Professional Design Consultant for the CRA
Waterfront Redevelopment Design
Addendum 1
Questions & Answers

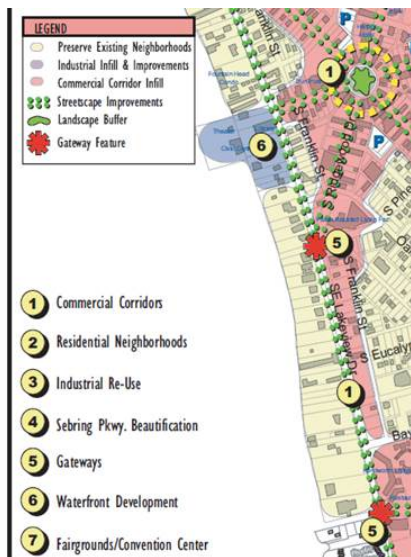
Can it be confirmed this project is limited to Area #6 (see below)?

Yes

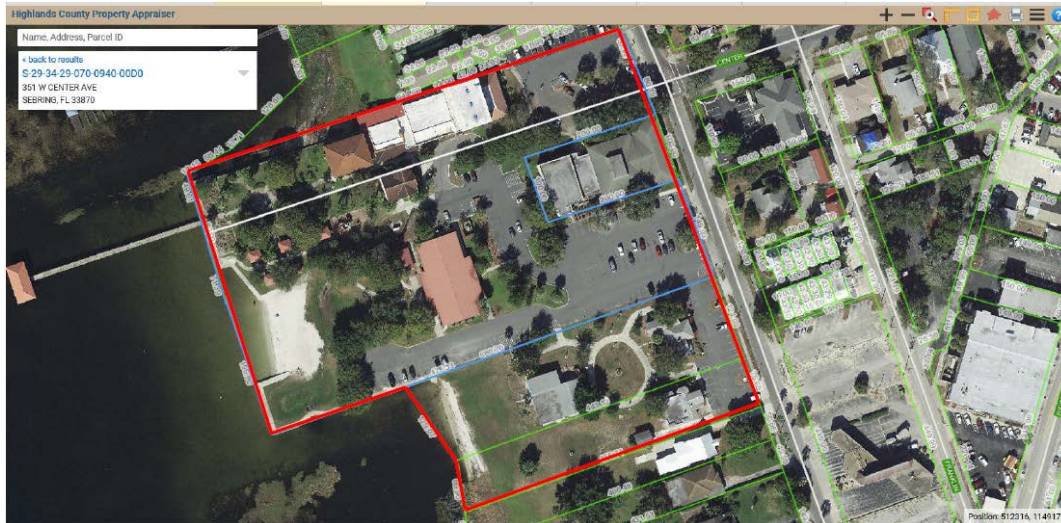
We'd like to confirm this project's limits of work is the land area(s) identified as "Public" abutting the waterfront on Figure 6 from the 1991 Master Plan? If not, could you provide an updated map outlining the specific limits of work? Thank you.

The project limits are within the red outline in the attached document.

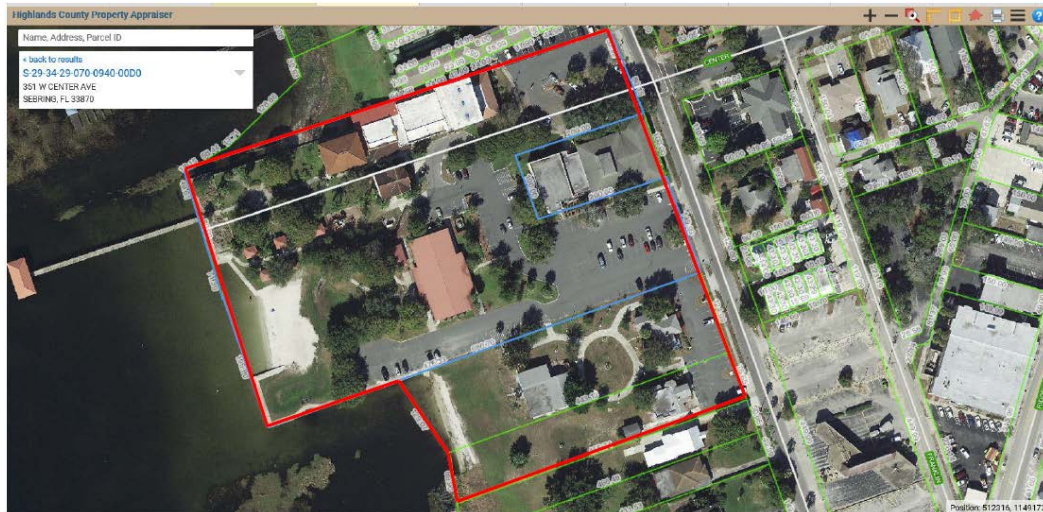
Can you please provide information on the limit of the site and what aspects of the previous waterfront master plan were implemented to date?

See attached for a map of the project limits. To my knowledge, no aspects of the waterfront master plan have been implemented to date.

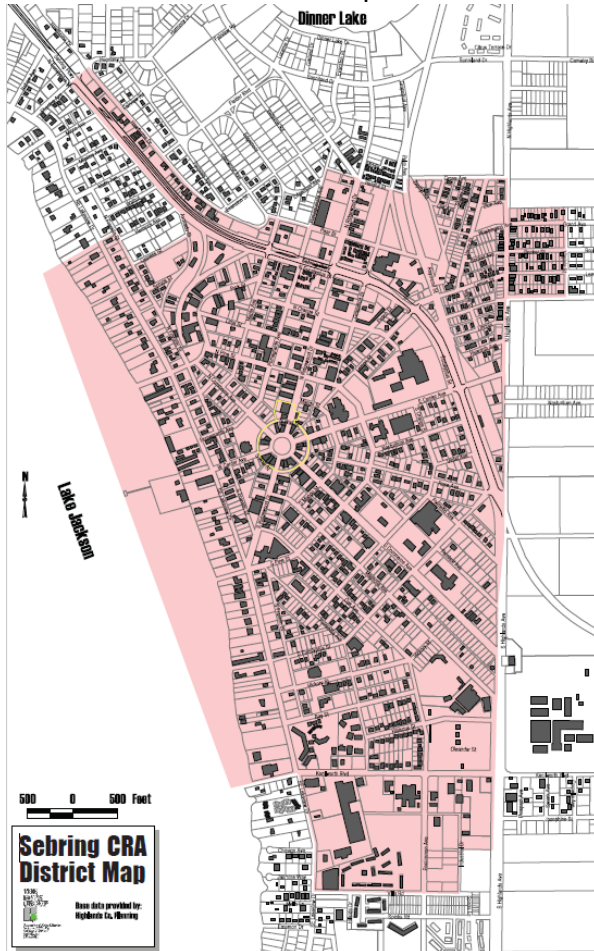
Please define the geographical boundaries of the City of Sebring CRA.

Please see the attached map.
